Access Compliance Report

Public Rights-of-Way

(Pedestrian Signals)

Intersection ID: N/A	Main Street:	Cross Street: N/A	Location: N/A
ADA ID: 1488BB9D85F2	Signal Type: One Push Button-Non APS	Overall Compliance: No	Severity Score: BTN 1: N/A BTN 2: N/A No BTN: N/A
Codes/Mitigation Info/Possible Solution		Field Measurements/Component Compliance

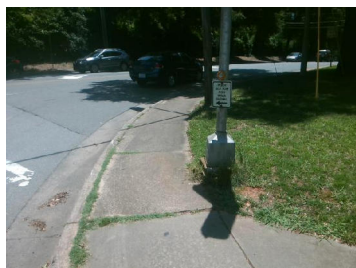
Possible Solutions: Provide Push Button Extension. Remove and Replace Clear Space.

PROW/ADA: R404.2, R404.3, R406.2
